US 27/SR 1 - HAMILTON ROAD WIDENING
Project No. NH-017-1(20)
P.I. No. 322250
Troup County

Value Engineering Study Report
Preliminary Design Submittal

December 2007

BEGIN CONSTRUCTION
WEBSTER STREET STA 9+70.00
N 1098377.1907
E 2034241.9654

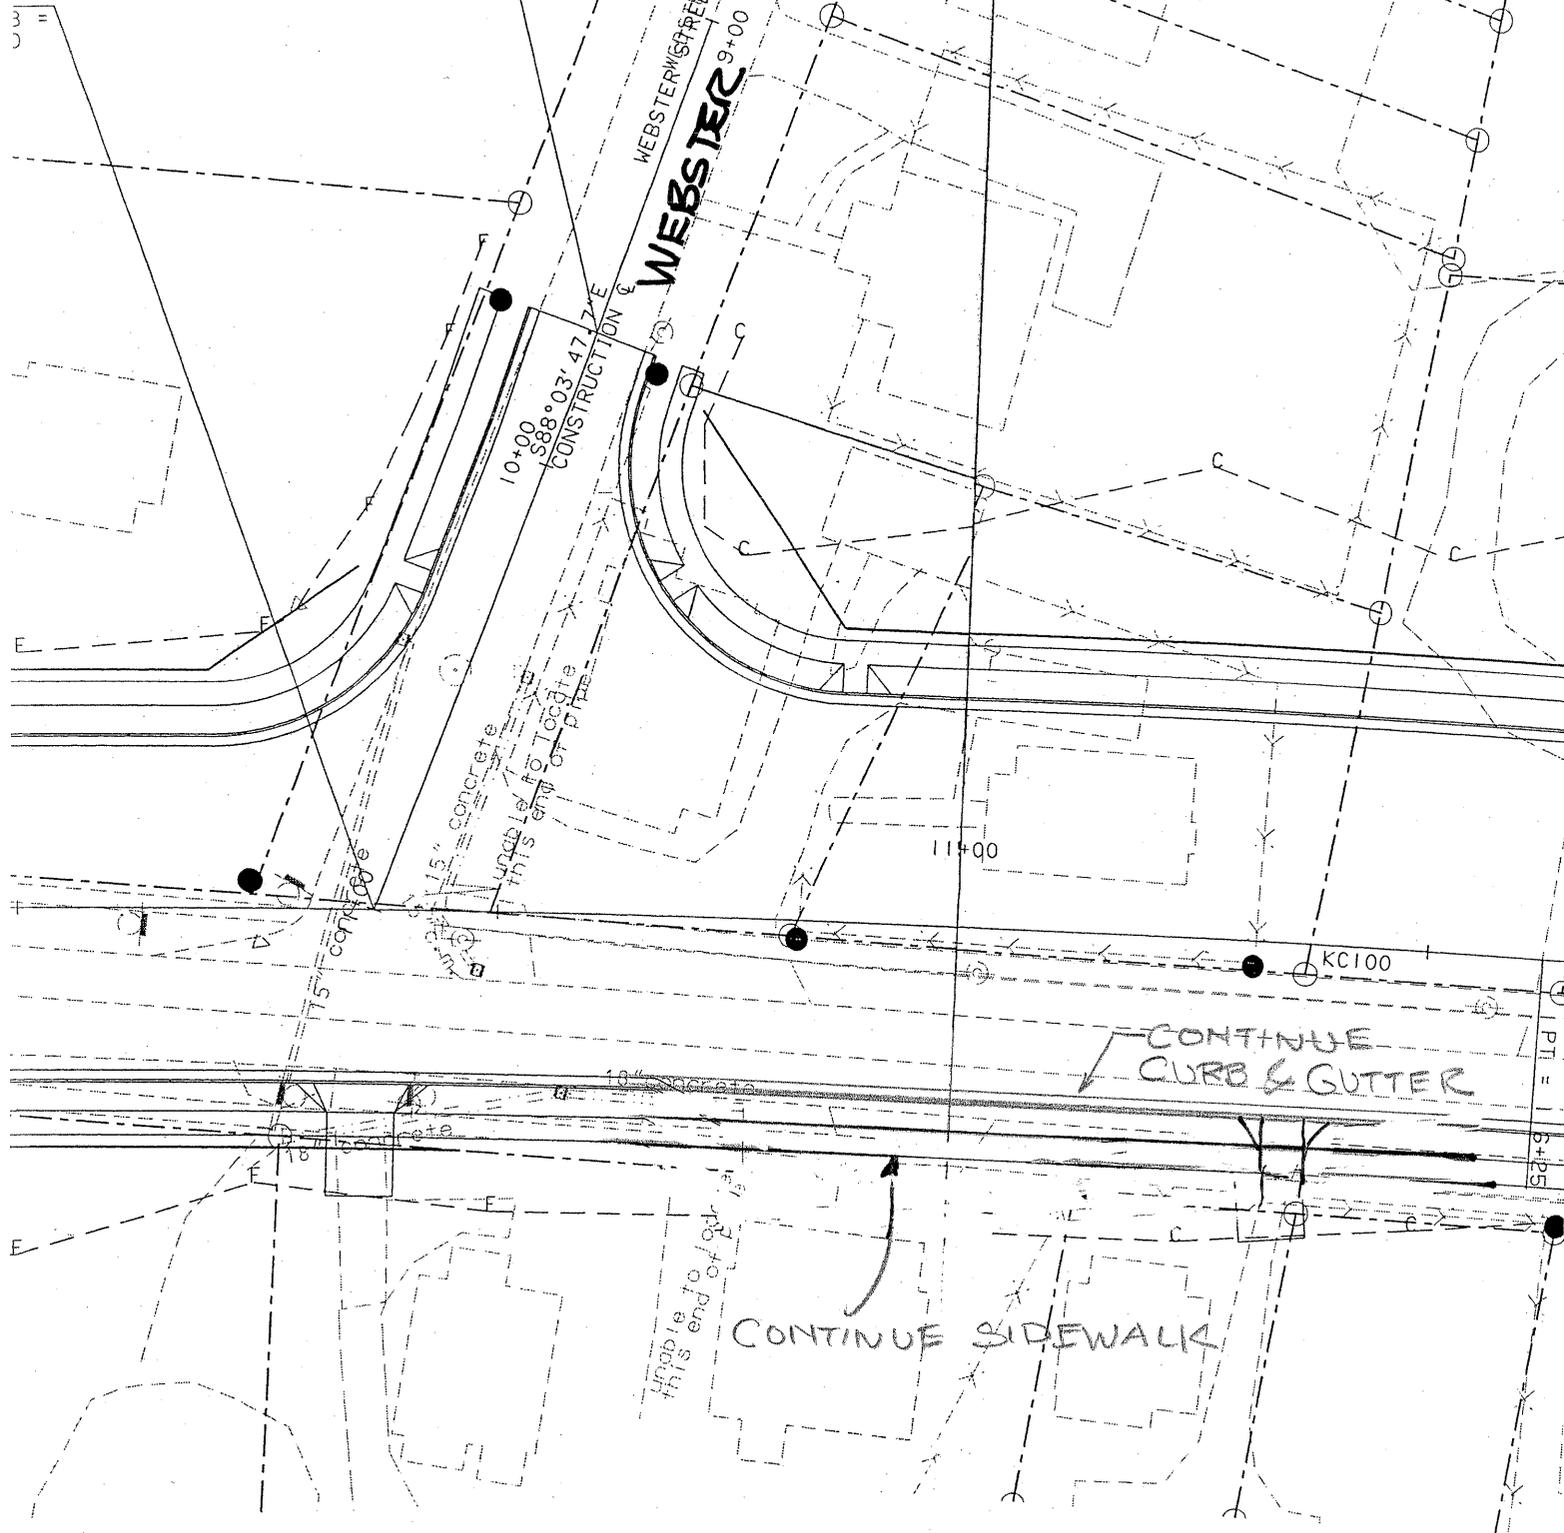
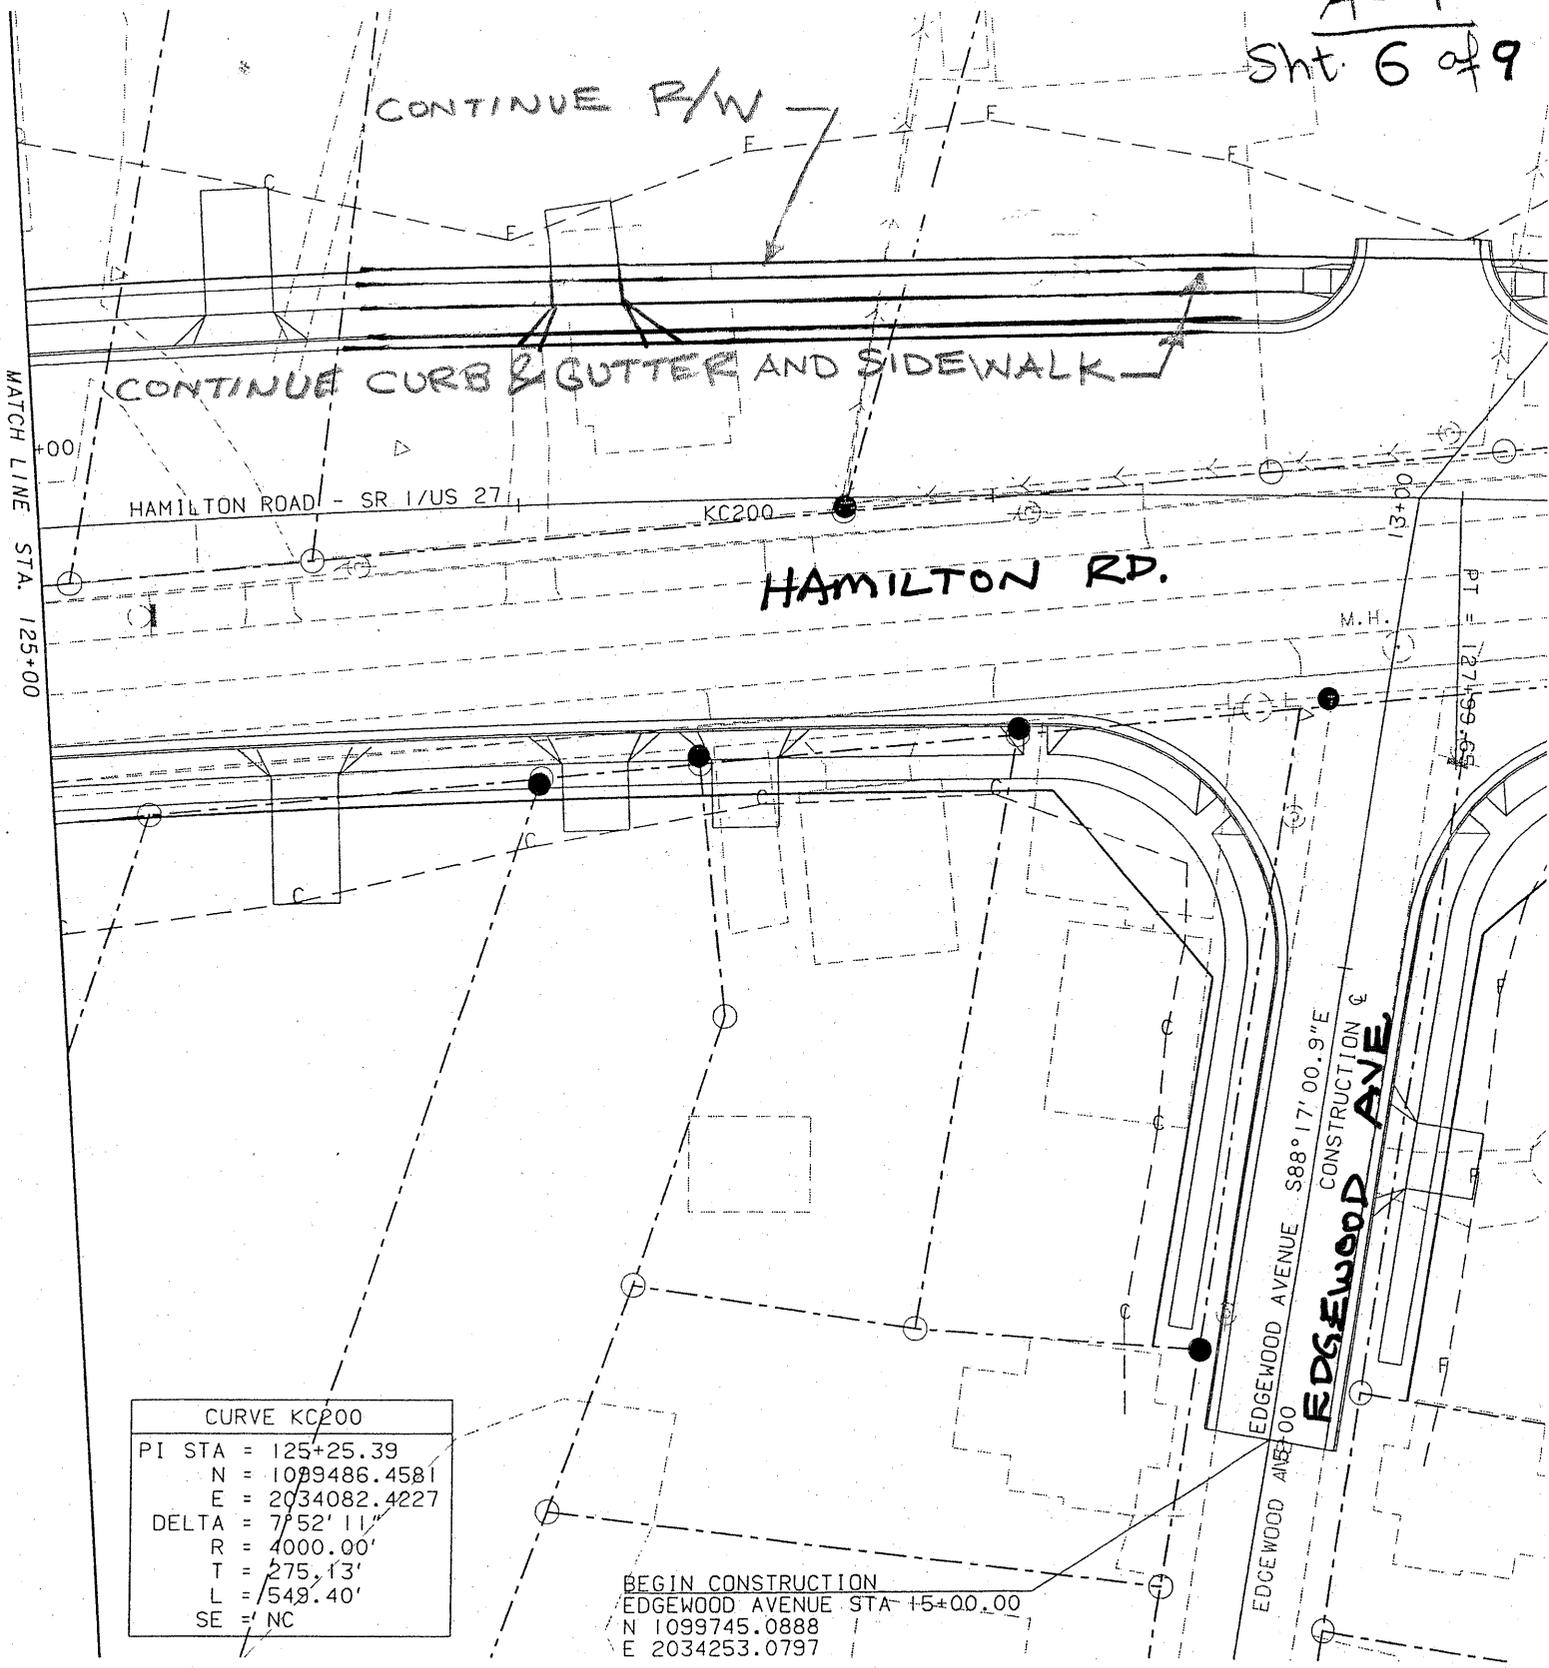
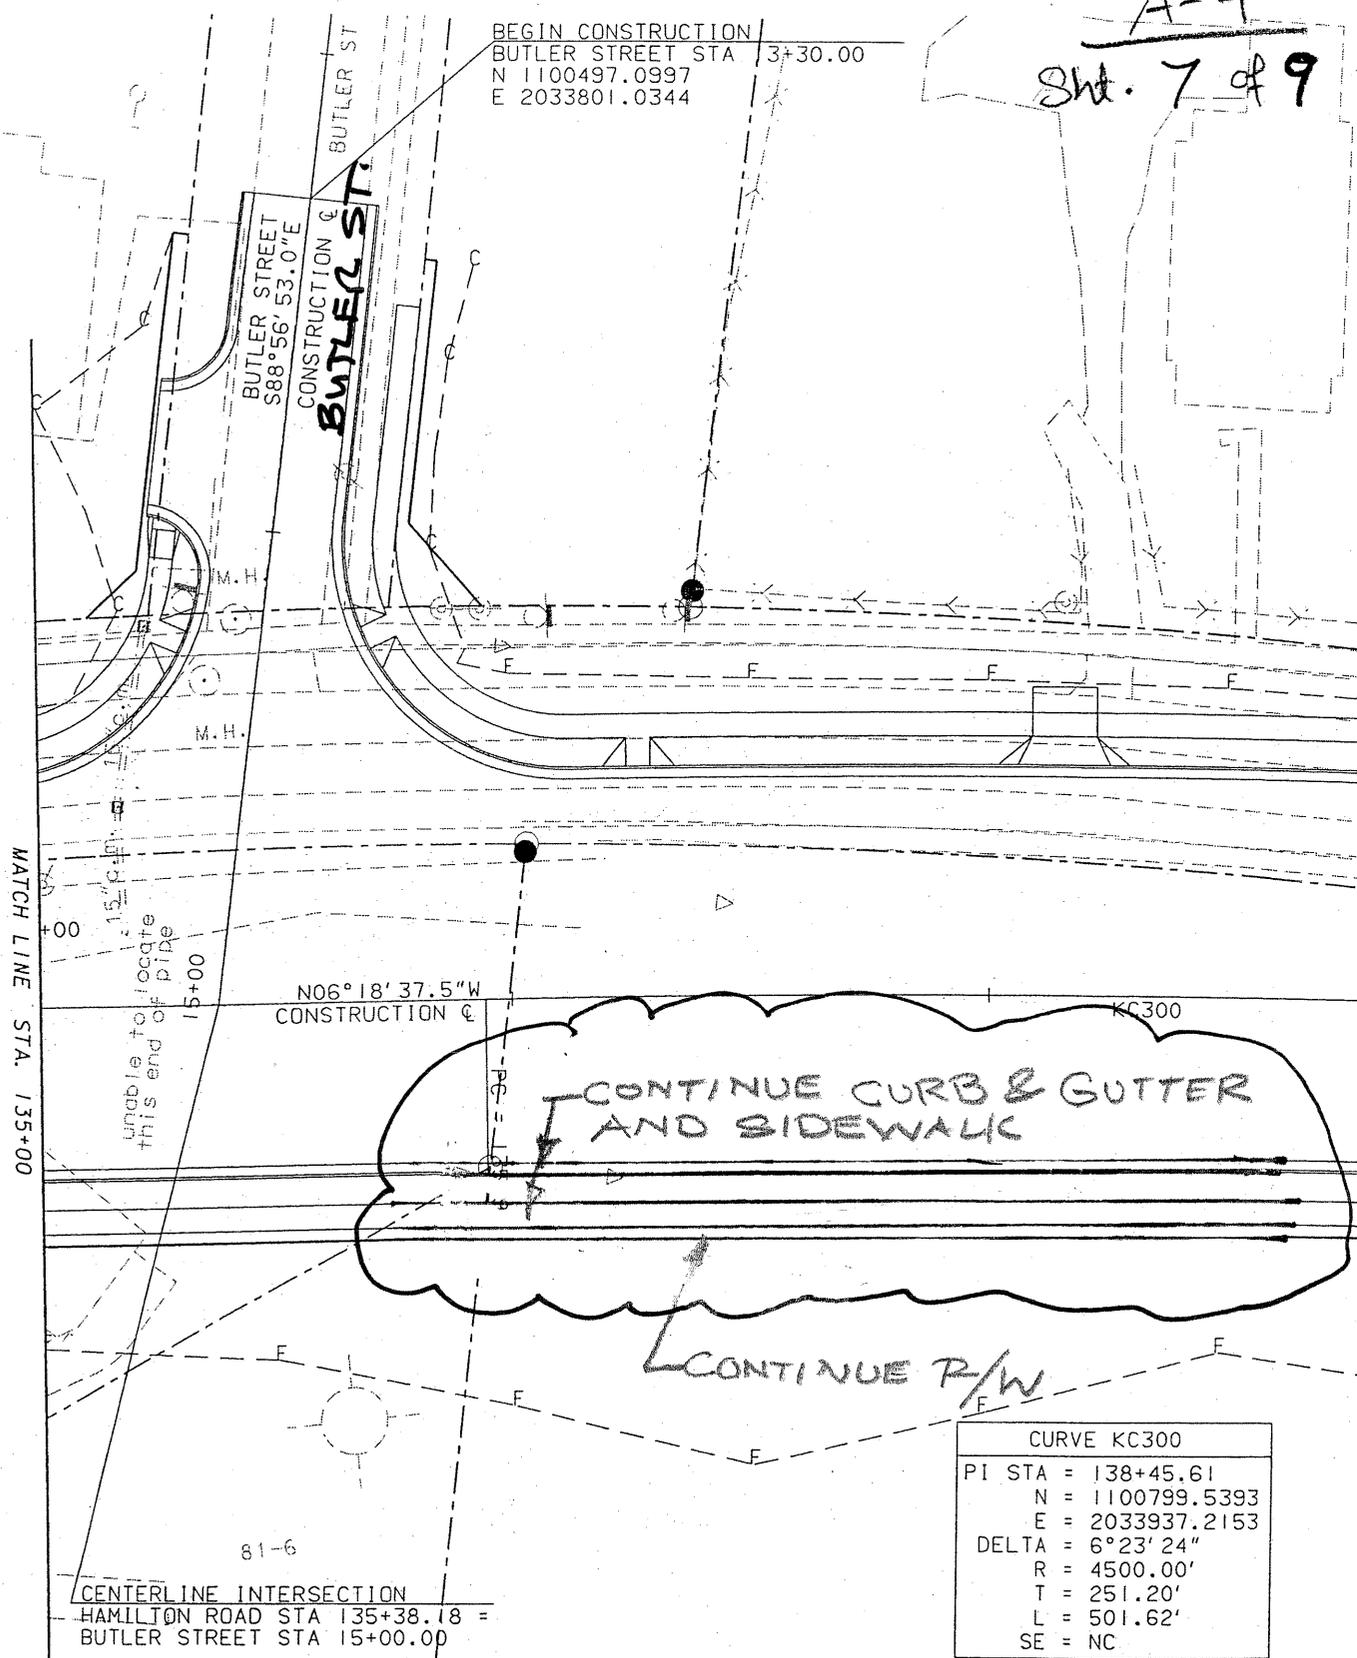
Remove the eyebrows on Hamilton Road opposite Webster Street, Edgewood Avenue and Butler Street. Continue curb, gutter and sidewalk.
